Facility/Item: Sapaj Klean, Boynton Bch

RE: Response to Request for Additional Information Regarding Request for Modification of  
Hazardous Waste Operating Permit No. HO50-195905

RE: Request for modification of Hazardous Waste Operating Permit Ho 50-195905  
(Submitted on October 26, 1992).

Figure II.A.1(c)-1  
Truck Traffic Patterns and Loading/  
Unloading Areas of Hazardous Waste  
Safety-Kleen Corp. Facility  
Boynton Beach, Florida

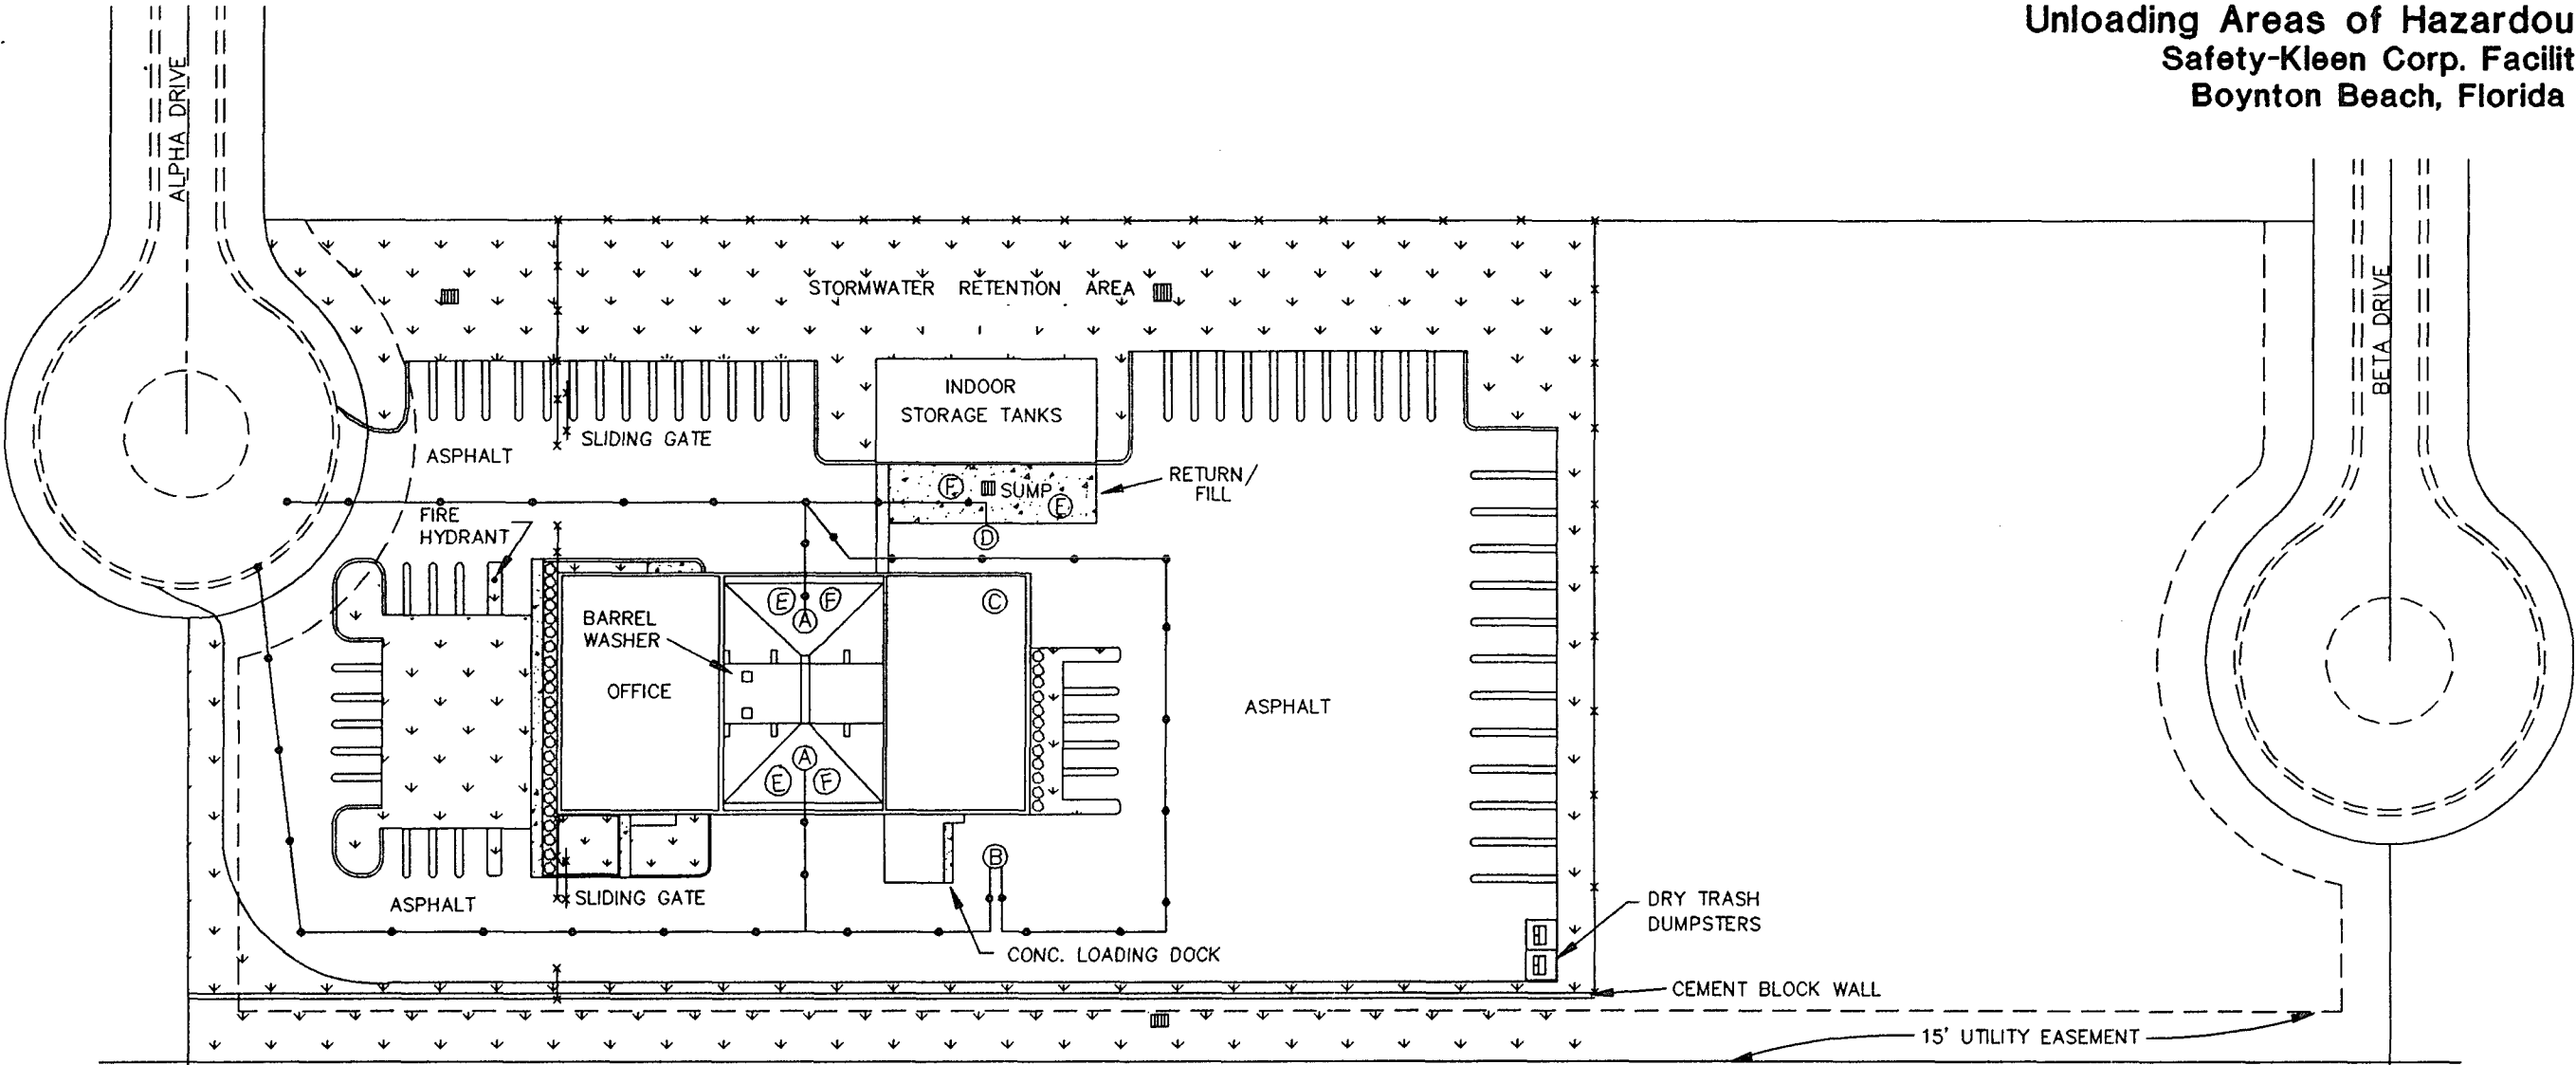
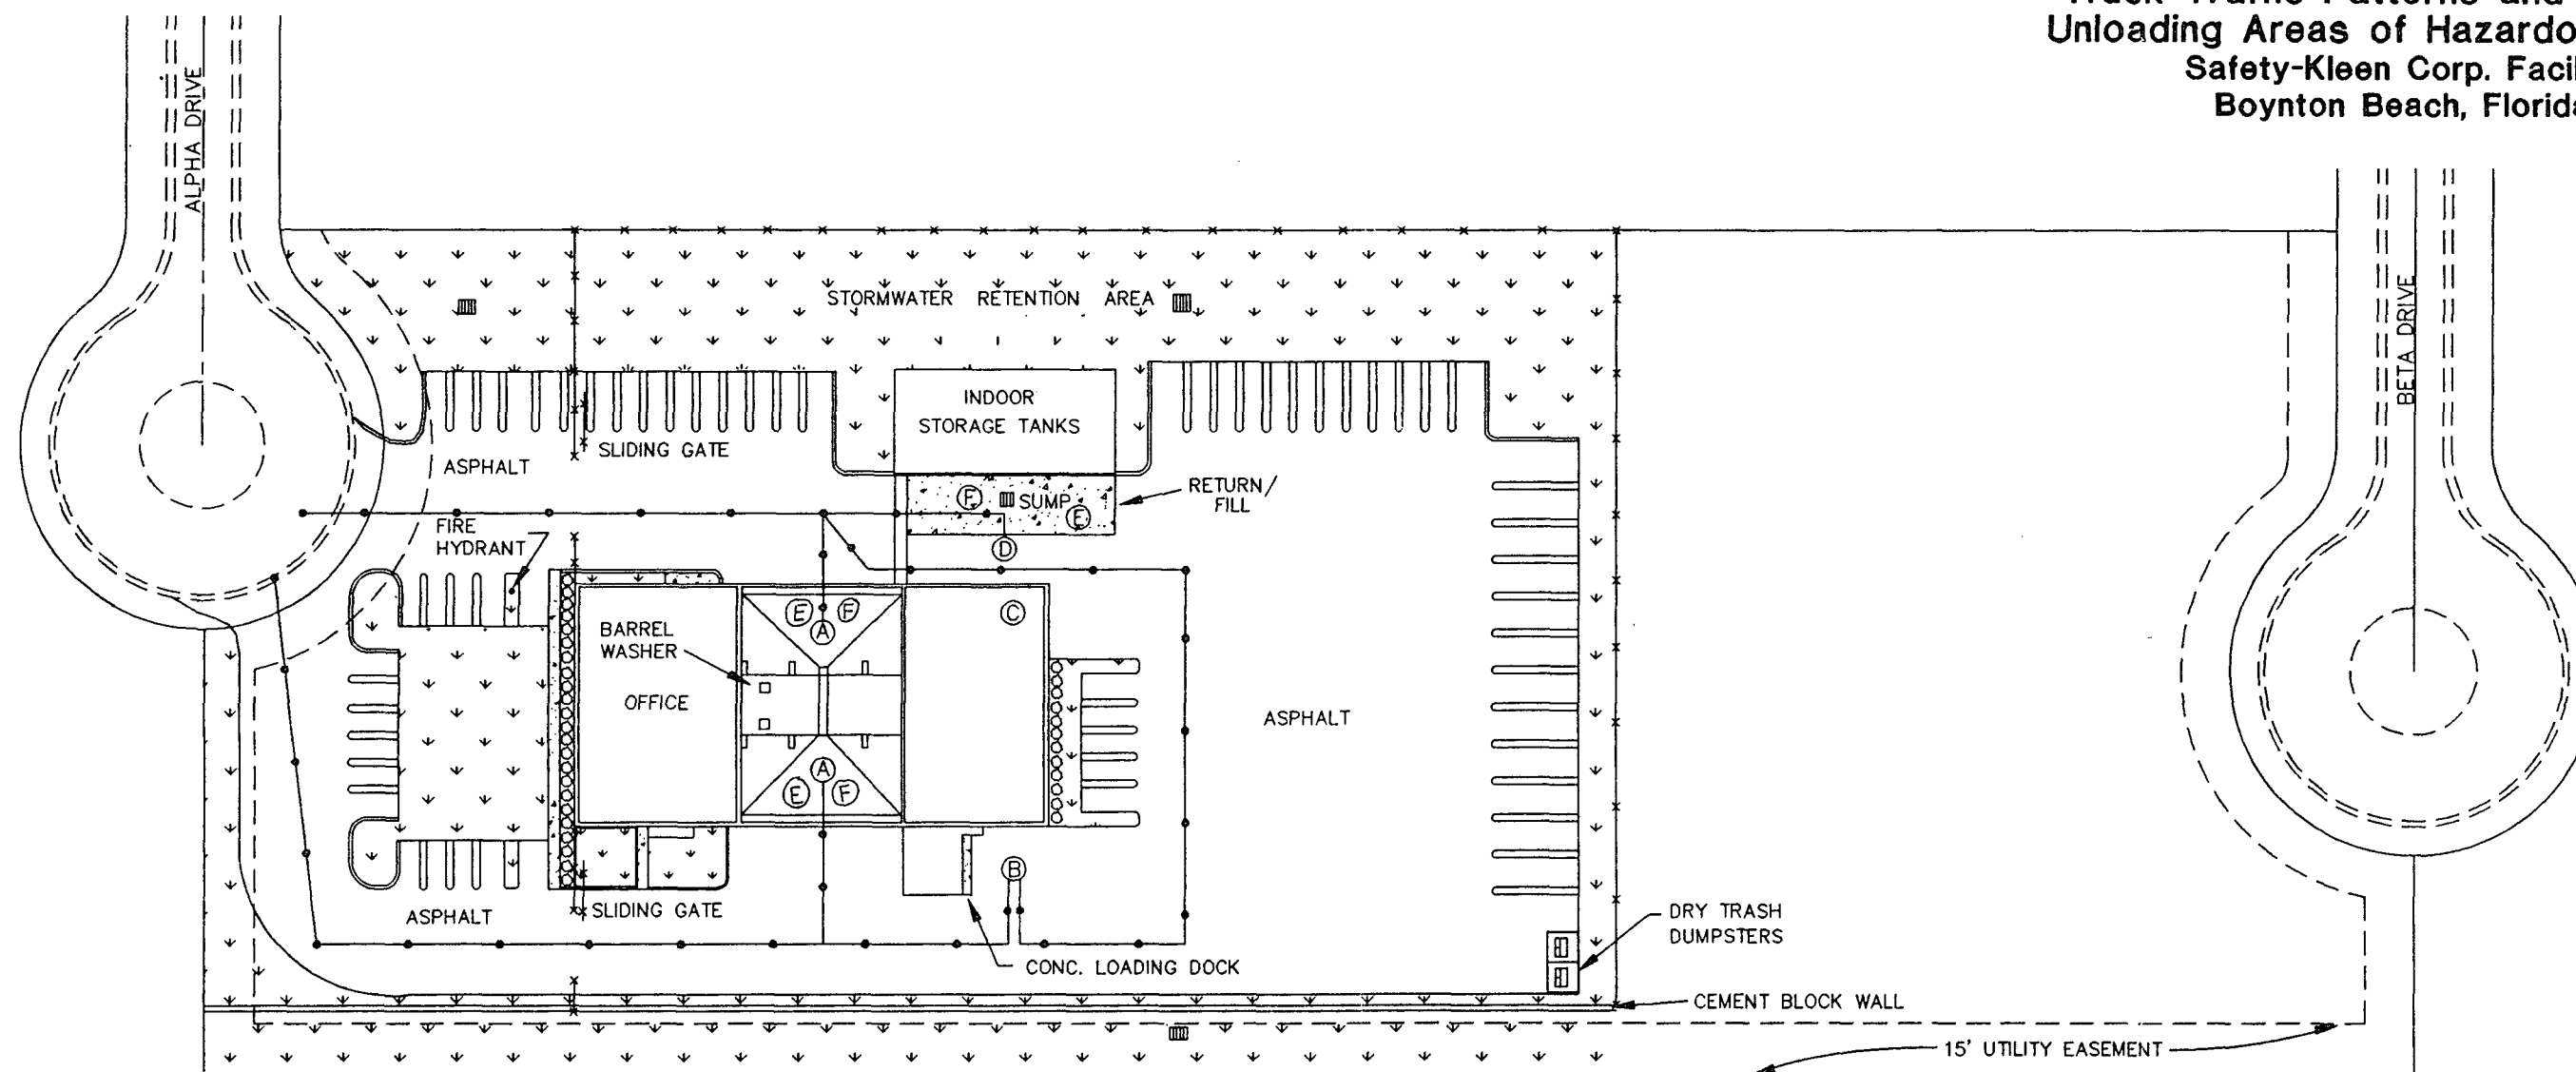
1. Safety-Kleen has requested that the permit include tanker truck to tanker truck transfer as an operating procedure. Safety-Kleen has provided a description and maps showing the location where the transfer may occur. The Department suggests that any truck to truck transfer of hazardous wastes should be conducted where secondary containment has been designed for such operations. The areas with appropriate secondary containment are shown in Figure II.A.1(c)-1. Either of the areas labeled "A" or that area labeled "D" would provide the containment necessary to prevent an accidental release from escaping to soils surrounding the facility. The transfer areas (Area E and Area F) proposed in Attachment I.B.3 do not take advantage of the safety features inherent to the facility's design. An accidental release could flow off of the asphalt and on to surrounding soils or flow down into the storm drain (not shown in Figure II.A.1(c)-1). Please submit a management procedure for truck to truck transfer which takes advantage of the containment systems designed and currently used at the facility for similar hazardous waste management activities.

The first item was with regard to the tanker-truck-to-tanker-truck transfer operations. SK has no objections to the agency's request to perform these functions within areas where secondary containment is available. The appropriate portions of the text and figures have been revised to indicate that tanker-truck-to-tanker-truck transfers will occur within the truck unloading area on the north side of the building. This area is sloped to a sump which provides secondary containment.

The nonbuilding areas of the facility are paved with asphalt, concrete, or gravel as noted on the site plan (Figure II.A.1(c)-1). The stormwater retention area is vegetated with grass. The majority of the vehicular traffic (step side and one-ton box trucks) and loading/unloading operations occur at and near the return and fill area A and it is paved with asphalt and concrete (Figure II.A.1(c)-1). Approximately once per week a tractor trailer brings fresh drummed solvents and removes used drummed solvents for transfer to the recycle facility. This truck backs up to the eastern side of the concrete dock, located on the southern side of the facility in area B to load and unload drums. Area C will be used for the loading/unloading of transfer wastes and containerized permitted wastes from local area vans and trucks. Area E will be used for the truck-to-truck transfer of FRS wastes. Truck-to-truck transfer of spent ethylene glycol may occur in Area F. The transfer of wastes will occur only in areas with secondary containment.

NOTE: E & F OCCURS ON THE TRUCK PAD  
NORTH OF THE WAREHOUSE
